CONSTRUCTION PERMIT

PERMIT NO.: 95-22-S
FILE: Sigourney-Sewage
RE: Industrial Park
PROJECT NO: S94-392

VARIANCE REQUEST

VERTICAL SECTION
GRINDER PUMP STATION DETAILS

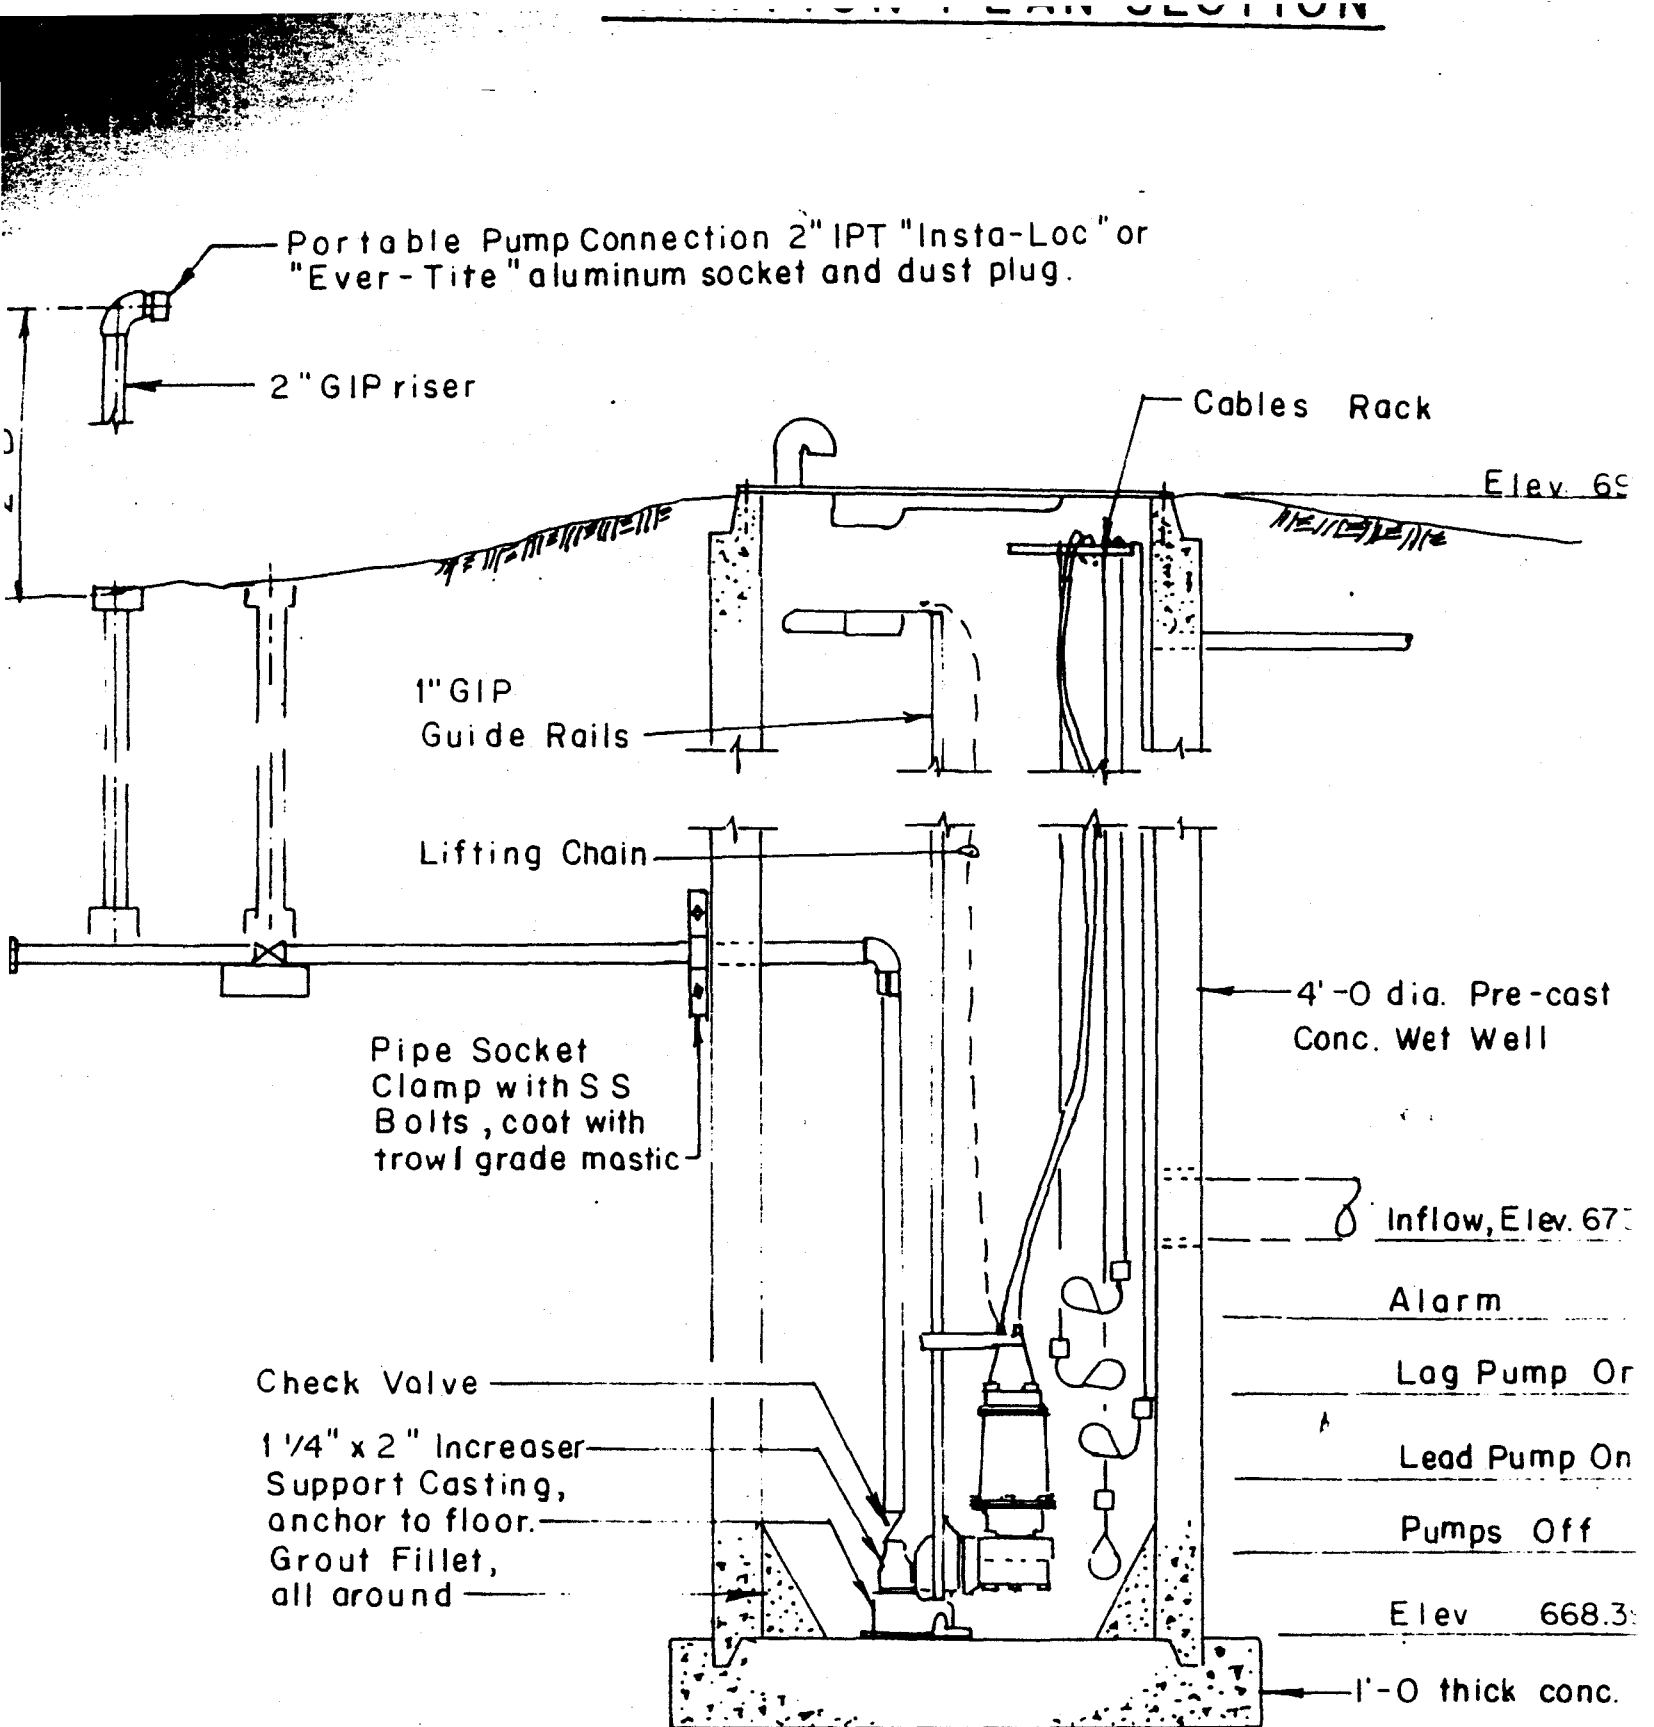
On behalf of the owner, we request that a variance be granted to allow the pump shut off valves to be buried outside of the wet well rather than to have them in a separate valve pit. We believe that burying these valves is inherently safer since they do not create a confined space that someone can enter. If valve maintenance is required, they can be excavated very quickly. With either method, the system would need to be temporarily shut down for valve repair. Of course, the check valve for each pump will be attached to the pump lift out assembly so that its maintenance can be conducted outside of the wet well (or valve pit).
